402 LEE STREET
DECATUR, ALABAMA 35601
MAY 4, 2026

Council Chambers	**Regular City Council Meeting**	**6:00 PM**

DATE:	May 4, 2026
SUBMITTED BY:	Hunter Allen,Park and Recreation
ITEM TYPE:	Change Order
AGENDA SECTION:	RESOLUTIONS:
SUBJECT:	Resolution No. 26-106: Approve Wilson Morgan Rec Center OCO #8
FINANCIAL IMPACT:	NA

Decatur Parks and Recreation
Rec Center Change Order #8

Attachments
RFI#174 - Rooftop Equipment Venting Conflicts MARKUP.pdf

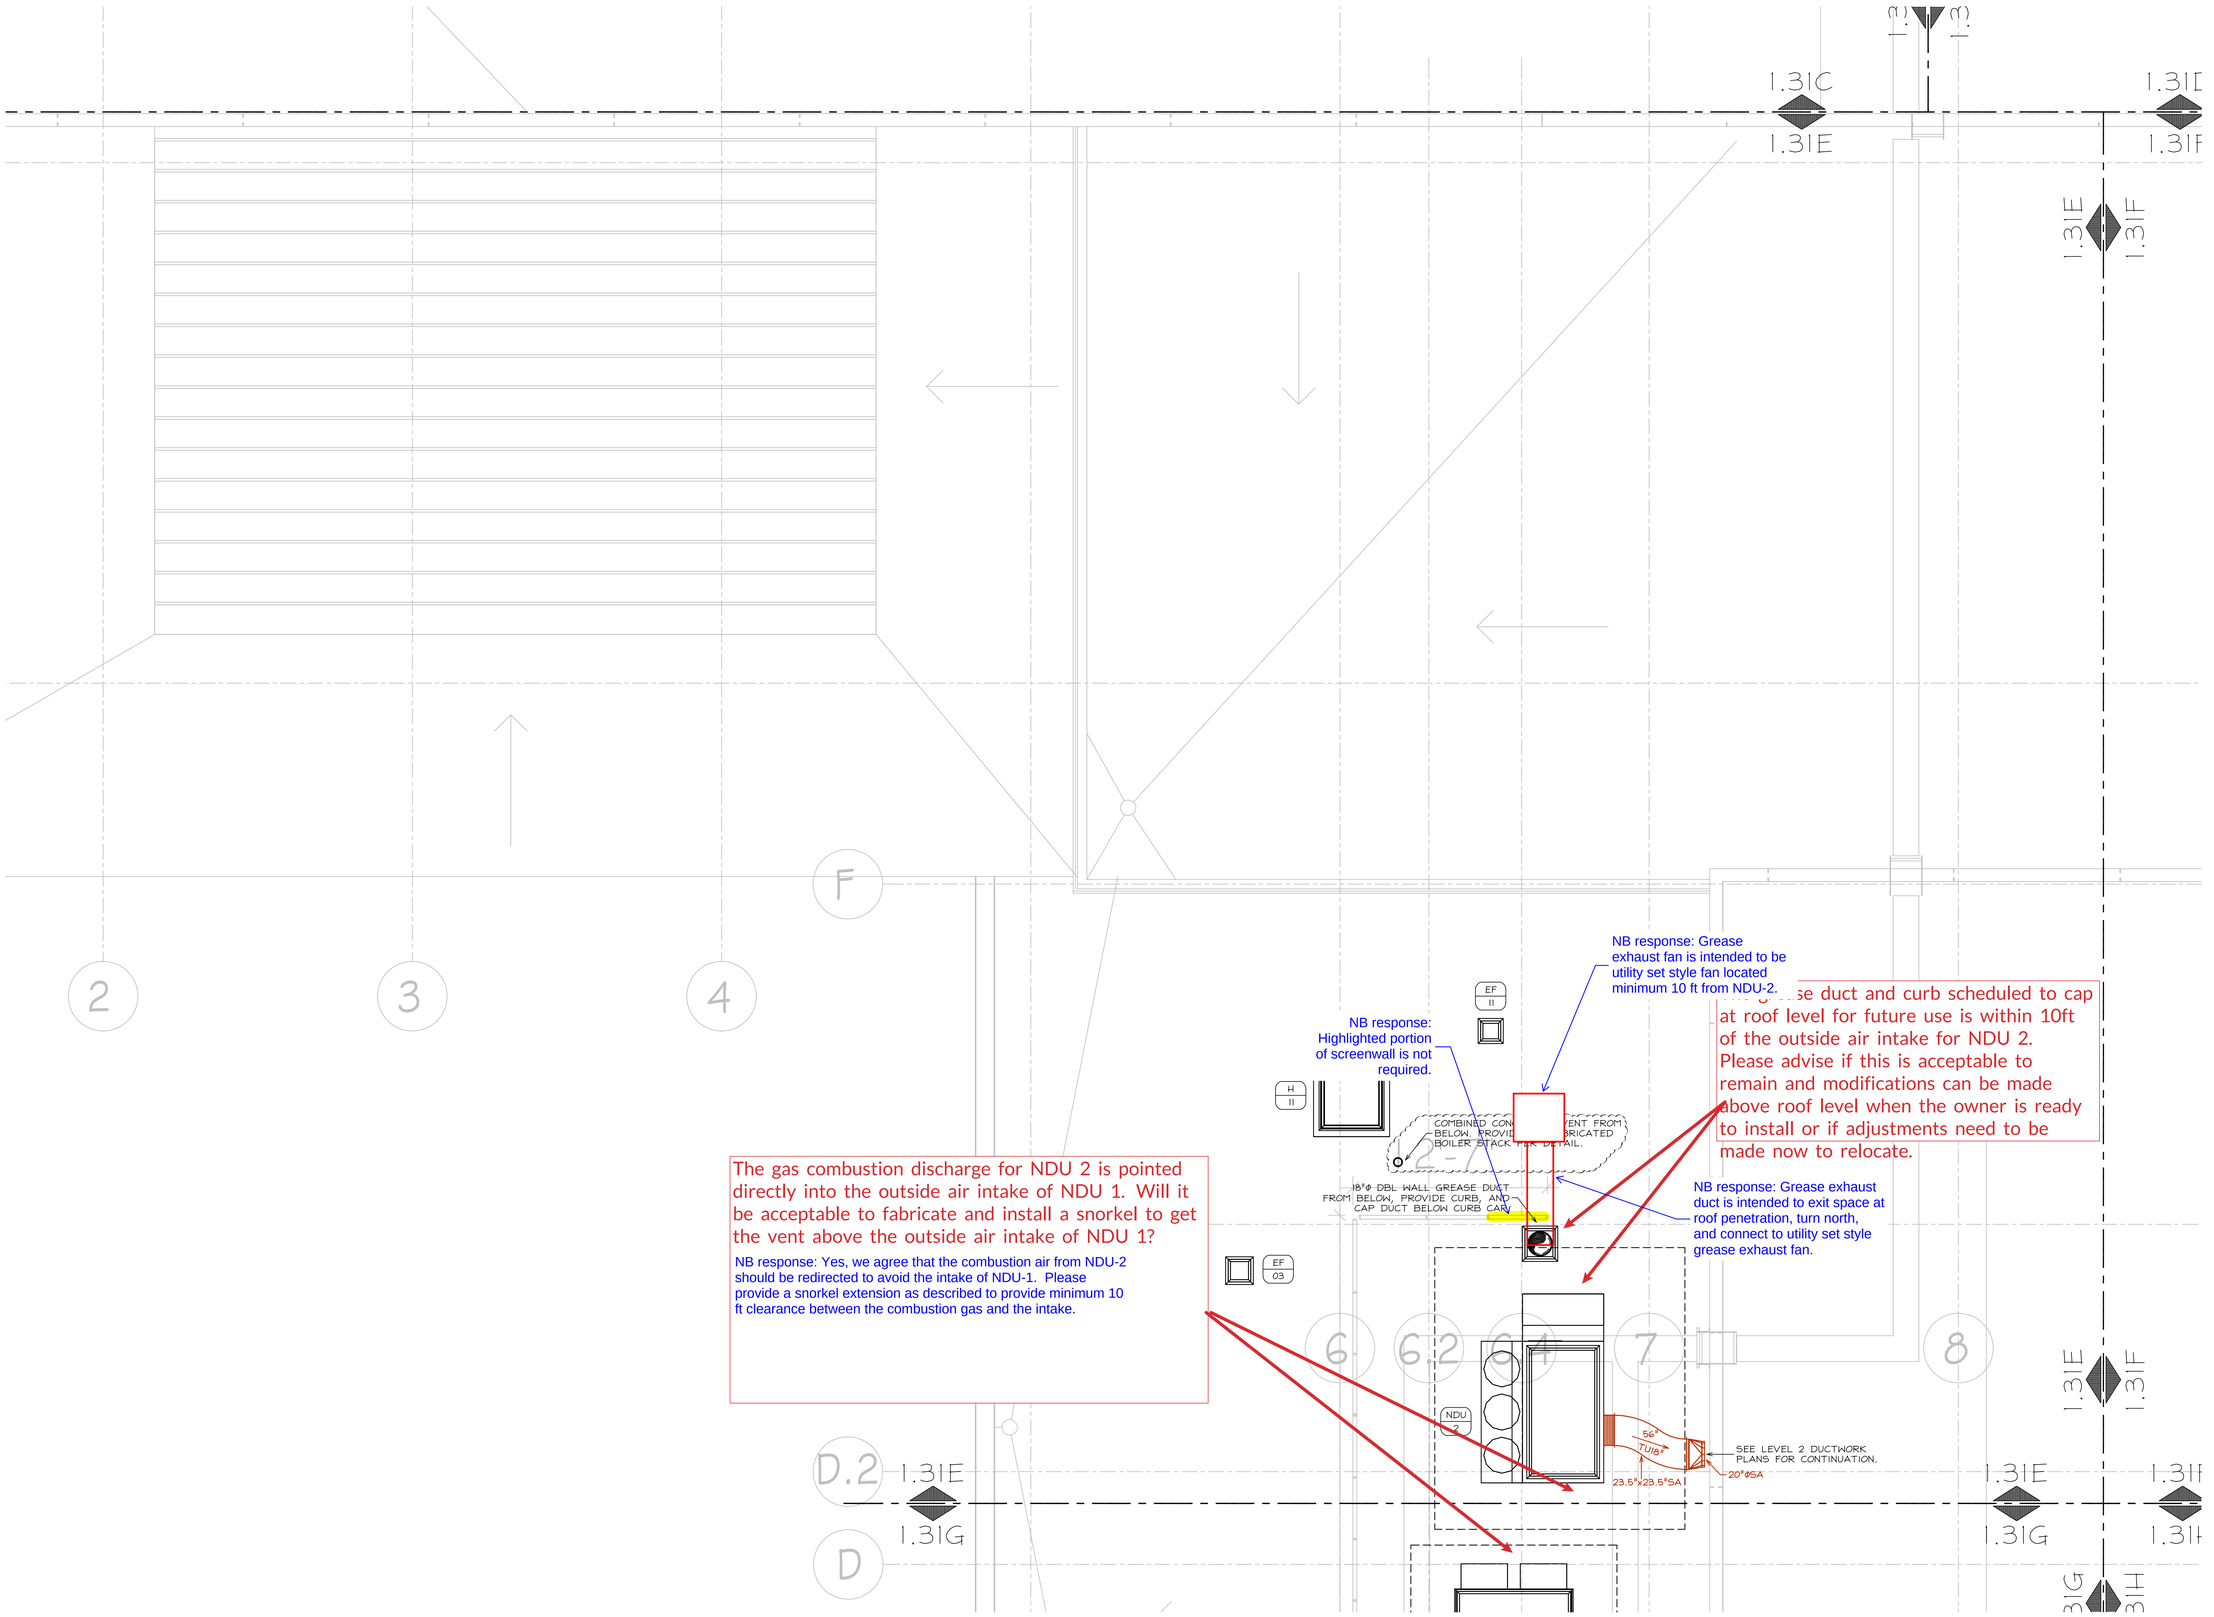
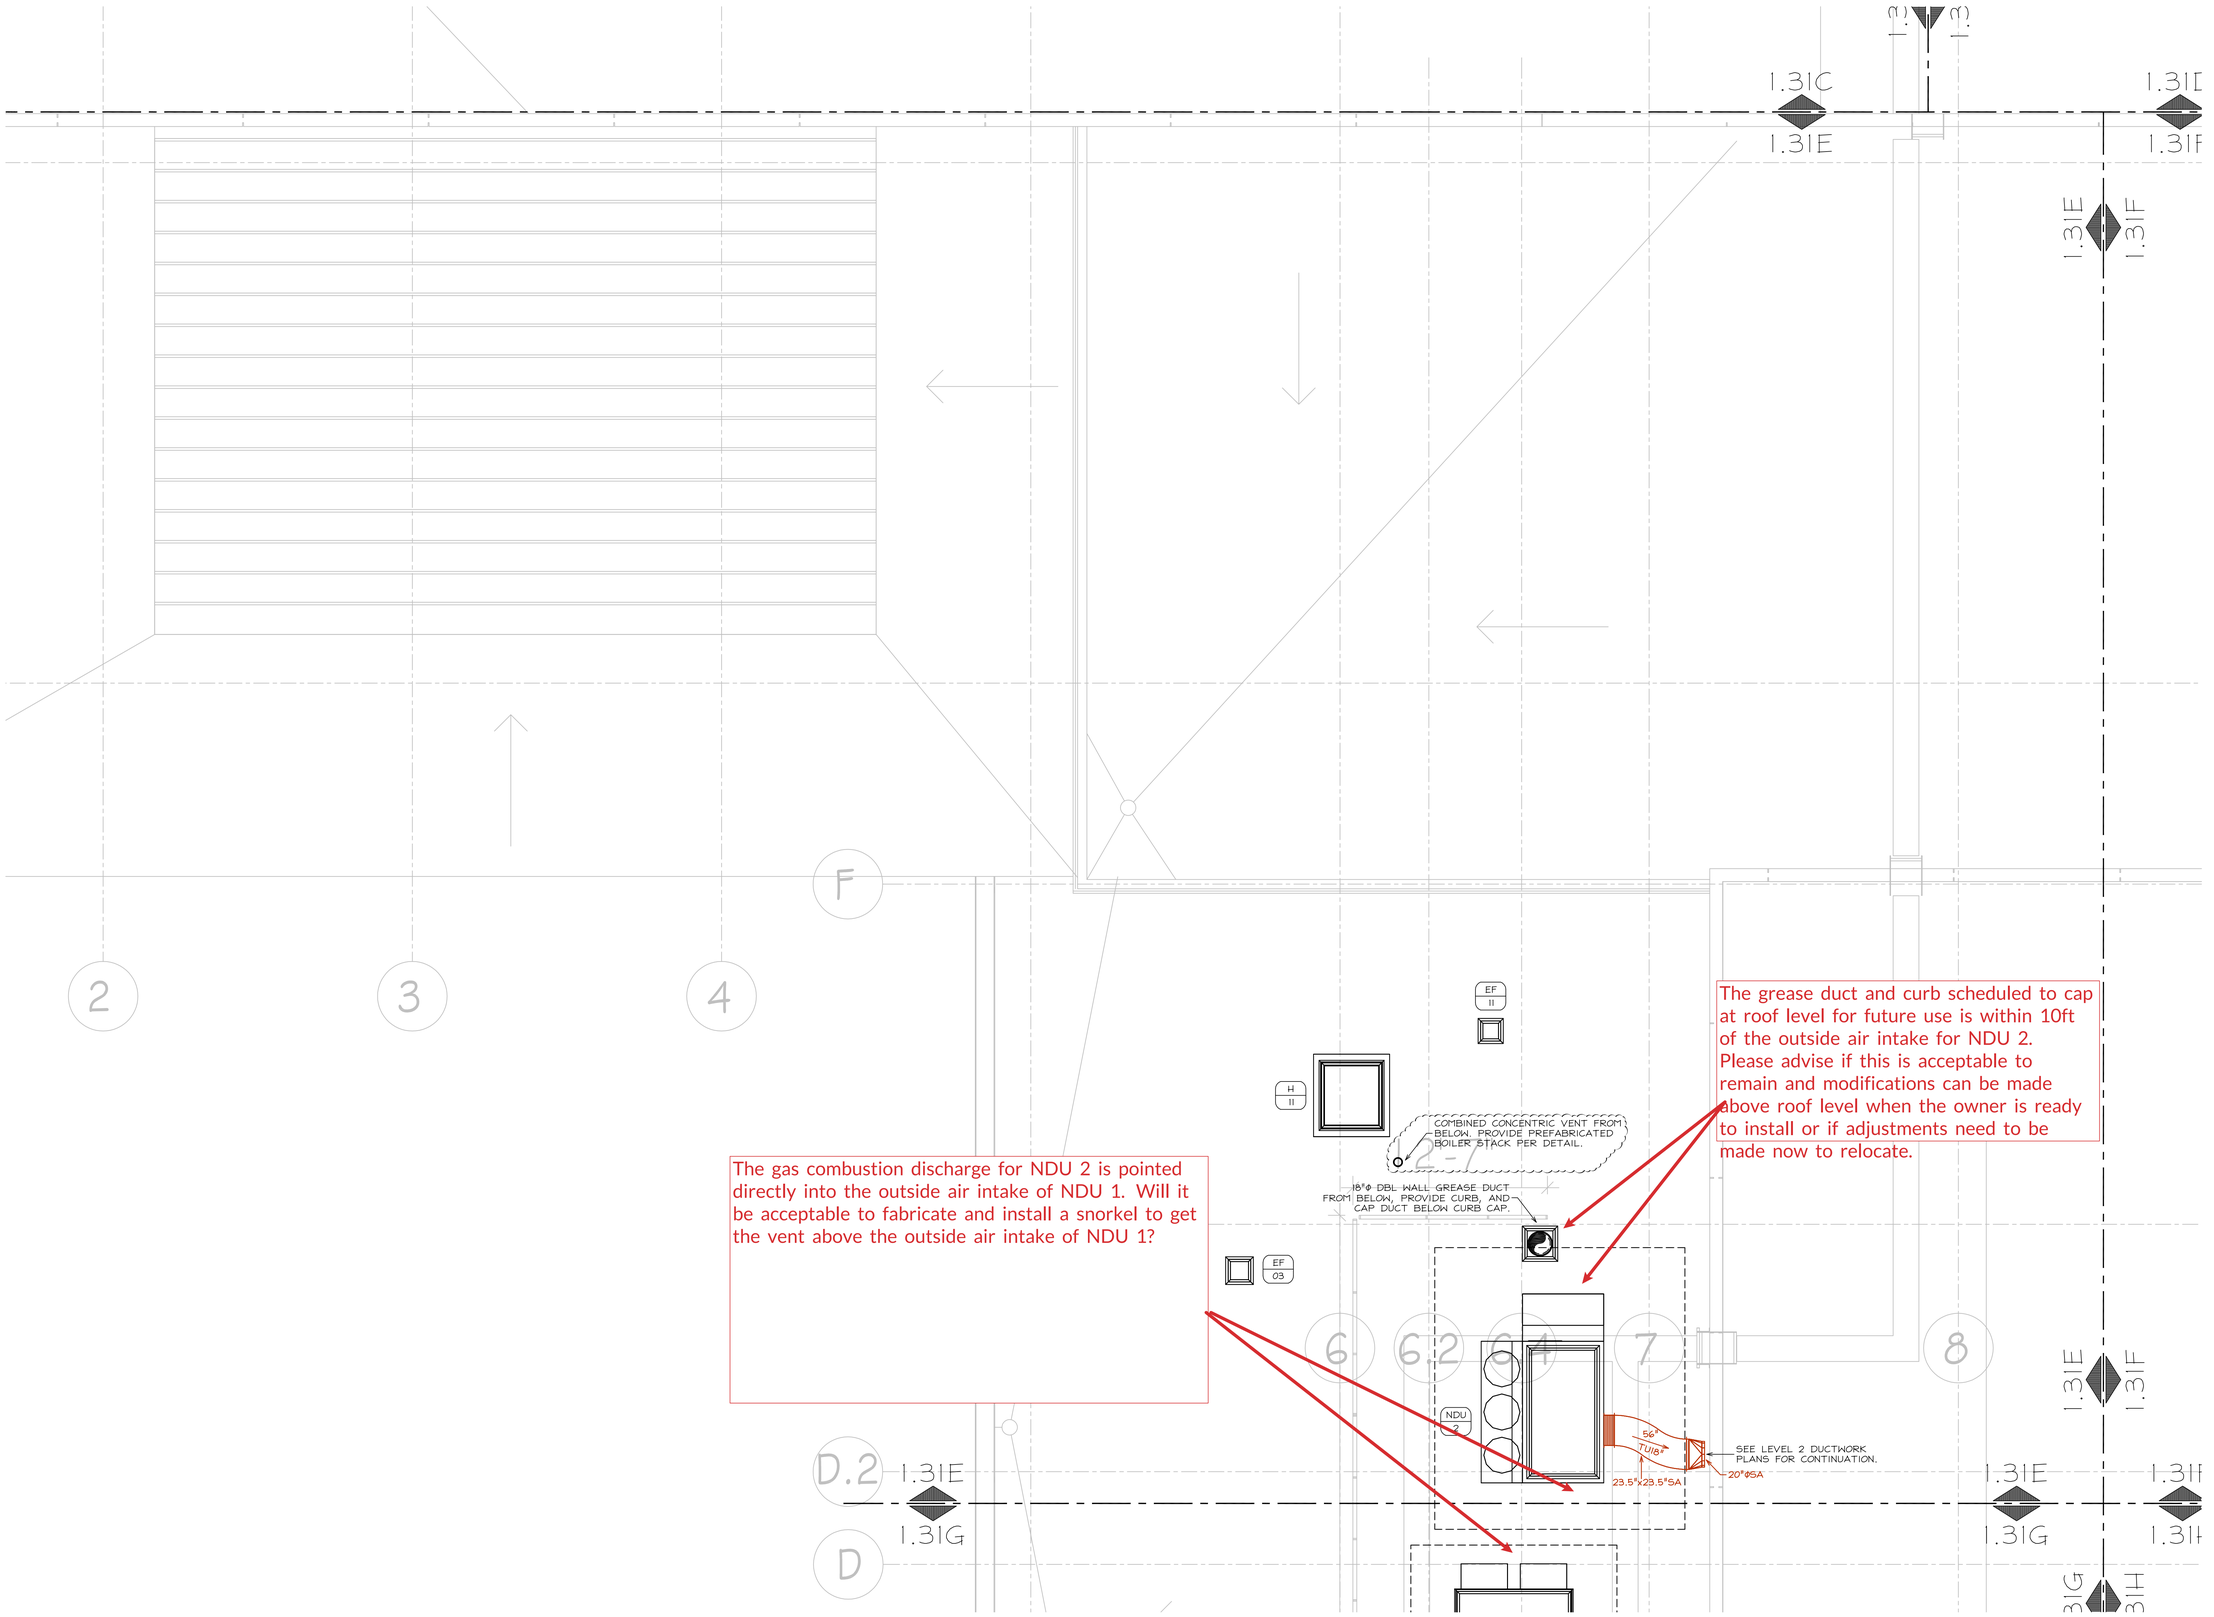
1). The grease duct and curb shown on the attached drawing 1.31E is located about 6ft from the outside air intake of NDU 2. Please advise if this curb and duct need to be relocated or if this can remain and modifications be made at roof level to offset away from the intake when the owner decides to complete.

2). The combustion air discharge for the gas heat on NDU 2 is pointed directly towards the outside air intake for NDU 1. Can a snorkel be fabricated and installed to get this discharge above the outside air intake level? See attached drawing 1.31E for reference.

2 E4.01 LARGE SCALE KITCHEN & DATA ROOM 107
SCALE: 1/4" = 1'-0"

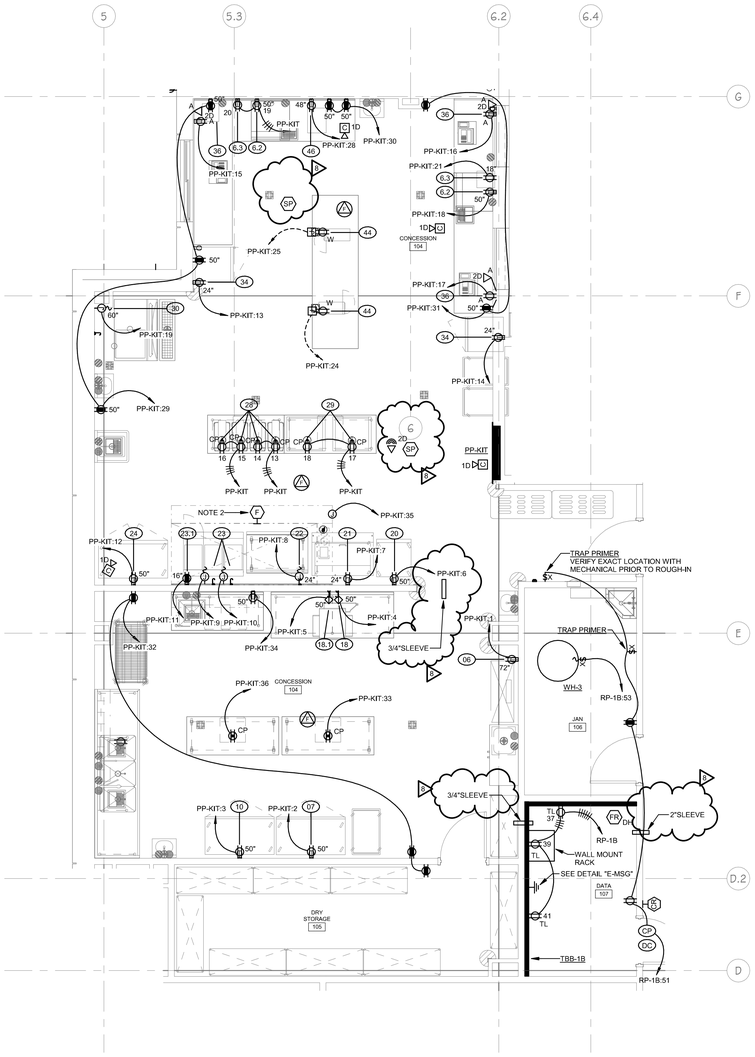
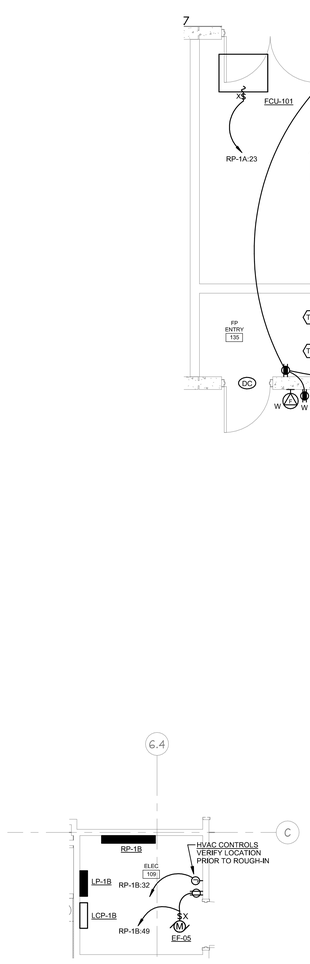
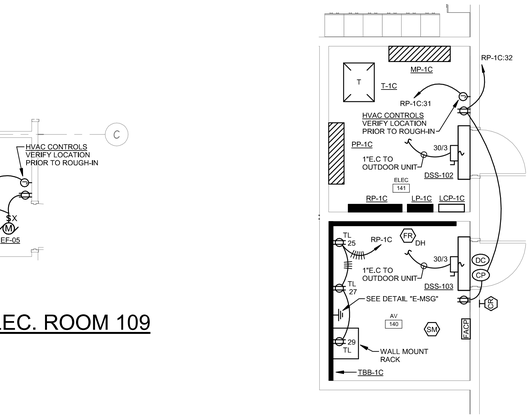
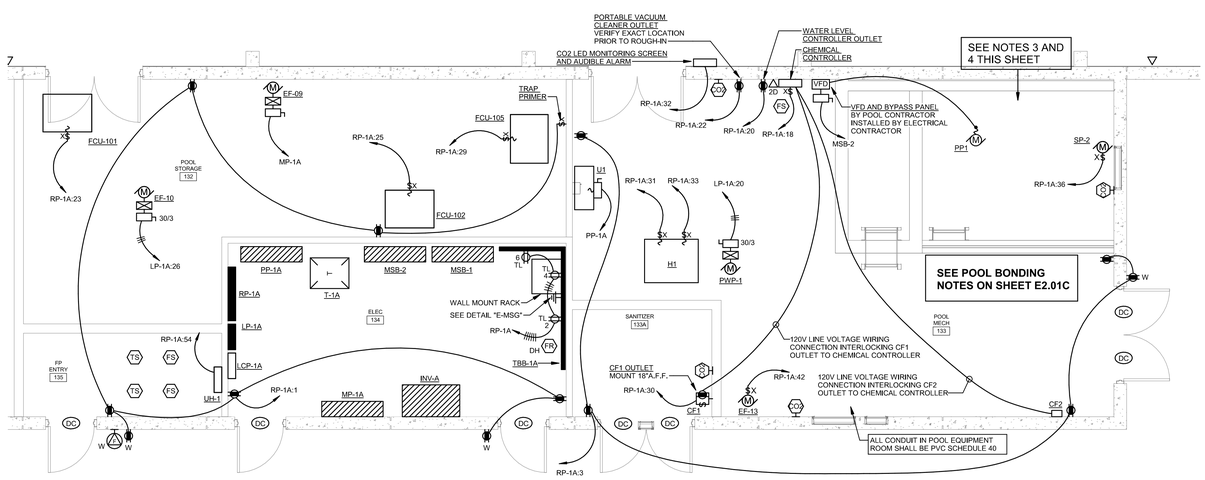
G. Reference Sheet E4.01 Large Scale Electrical Plans
   - Added conduits and sleeves for sound system speakers.
H. Reference Sheet E7.02 Legend & Notes
   - Revised legend entry for speakers and speaker conduits.
